Service Bulletin No. 408

<i>MODEL</i>	E4500 / J4500 Series	<i>TYPE</i>	Field Change Program	<i>SECTION/GROUP</i>	3-Body	<i>DATE</i>	May 1, 2014
<i>SUBJECT</i>	PASSENGER SEAT TRACK WELD						
<i>CONDITIONS</i>

Ref. MCI NHTSA Recall No.:14V-172

Figure 3. Rear view of second row passenger seat base.

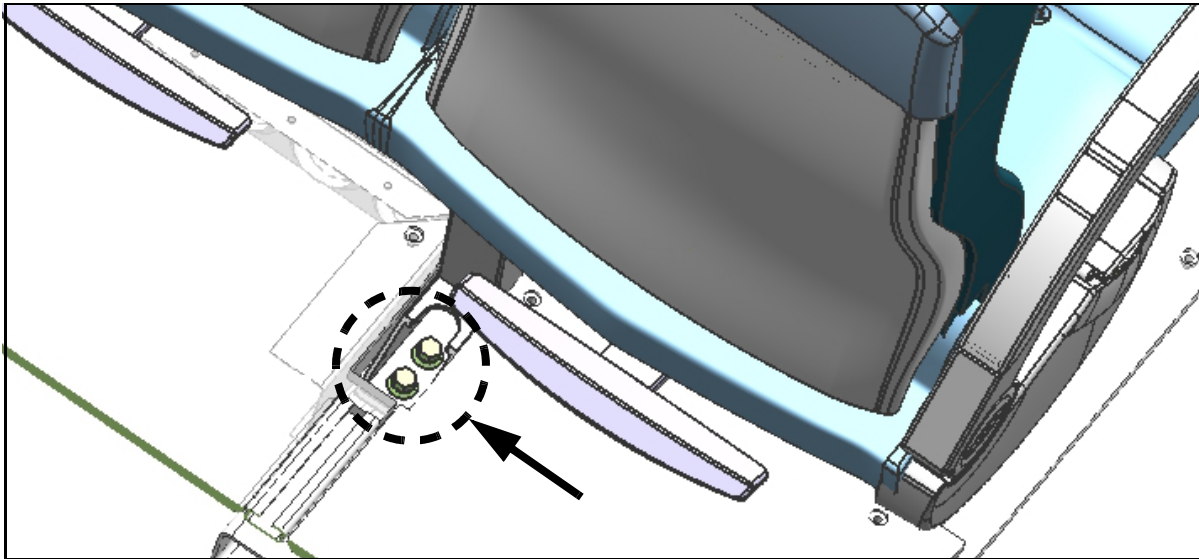
8. Locate the two (2) nuts from the seat track tee bolts located at the rear of the seat base (refer to Figure 3). Remove and discard the two (2) nuts from the seat track tee bolts.

9. Carefully tilt the passenger seat forward until the seat base clears the rear tee bolts in the seat track.
10. Twist to remove the two (2) rear tee bolts from the seat track. Discard the two (2) rear tee bolts.
11. Orient the passenger seat in its original position. Re-install the nuts on the front seat track tee bolts and sidewall mounting hardware. Torque nuts to 54-60 ft-lbs.
12. Using a drill with a 7/16 inch drill bit and the two (2) holes in the rear seat base (shown in Figure 4) as a drill template, drill two (2) holes (approximate depth of 1.00 inch) through the seat track and into the upper wall of the tubing underneath (located in the upper, front corners of baggage bay compartment #1).

Figure 7.

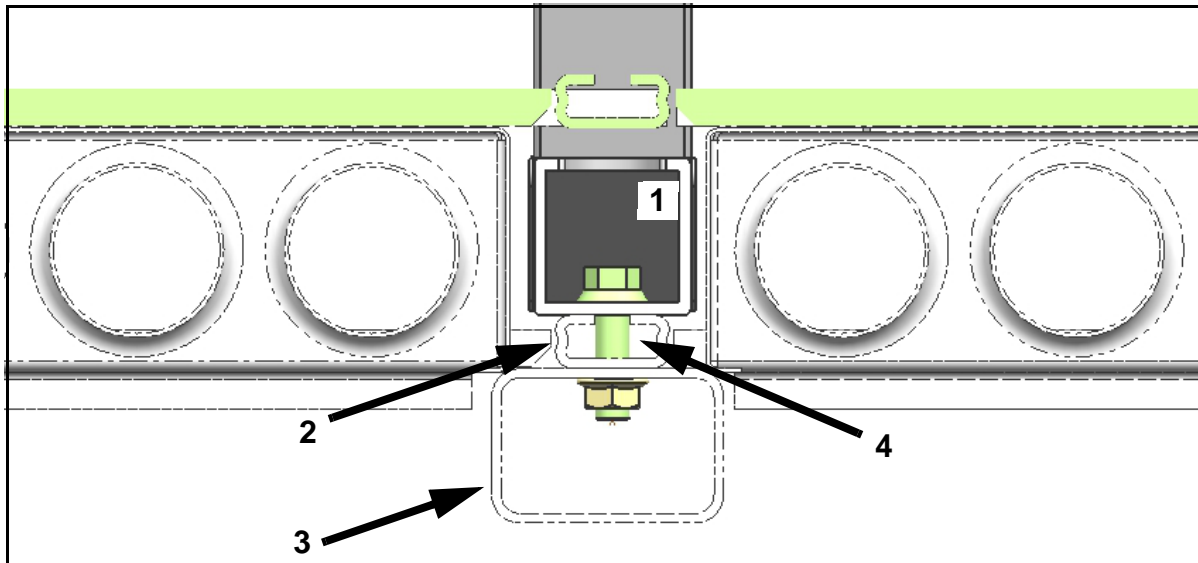
16. Locate the capscrew inside the tubing. Position the nut, p/n 19-03-0582, on the capscrew (refer to Figure 7). Torque capscrew to 76-80 ft-lbs.
